MEMO

Re: Review for an addition at 179-185 S RIVERVIEW STREET

THOUGHTS on the ADDITION at 179 S. RIVERVIEW STREET

5. Sketch of front elevation with addition located behind the main structure. The front porch and entry have been simplified to complement the saltbox style center bay.

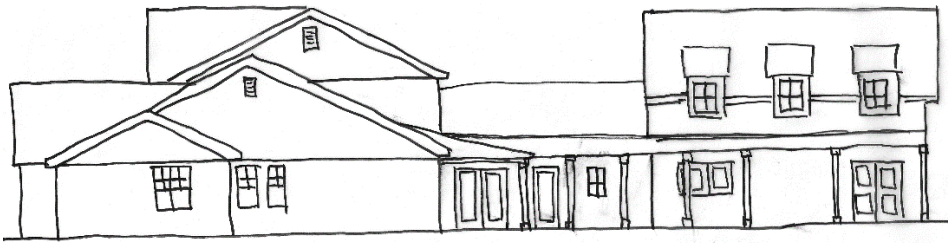
- Consider moving the new addition from the left of the main building and extending it behind the one-story side-gable room off the entry. The space would still flow from the dining room to the kitchen to the garage addition, but it would lessen the impact from the street.
- Re-think the saltbox roof and shed-roof porch entry. While the existing double-gable front creates some design challenges, the saltbox form is inappropriate with the other style elements. Generally, saltboxes were rather simple in form with few design elements. The elaborate door with sidelights and the extensive and deep front porch do not go with this building form. The composition needs to be simplified to match buildings in the surrounding area as well. Consider a different porch and door design.
- Removing the front-loaded garage doors and replacing them with windows is a nice addition to the building.

6. Sketch of south side elevation with addition located behind the main structure. The kitchen serves as a one-story hyphen connector between the garage and the main house.

7. Sketch of the rear elevation. The structure of the garage has been simplified so it does not appear so massive. And the front overhang by the garage doors has been removed. The rear porch wraps around to meet that of the main house.

8. Sketch of the north side elevation with the kitchen/garage addition extending behind the main house.

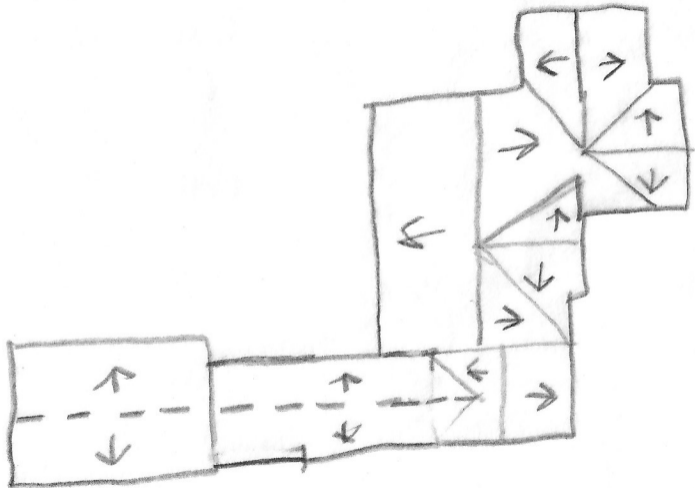
- Little can change due to the existing main structure.
- Moving the garage/kitchen addition behind the main house and connecting it with a continuous side-gable roof will allow for more space between the front structure and the garage addition so the composition appears less crowded.
- The roofline of the shed-roof rear porch should align with that of the garage/outdoor kitchen.
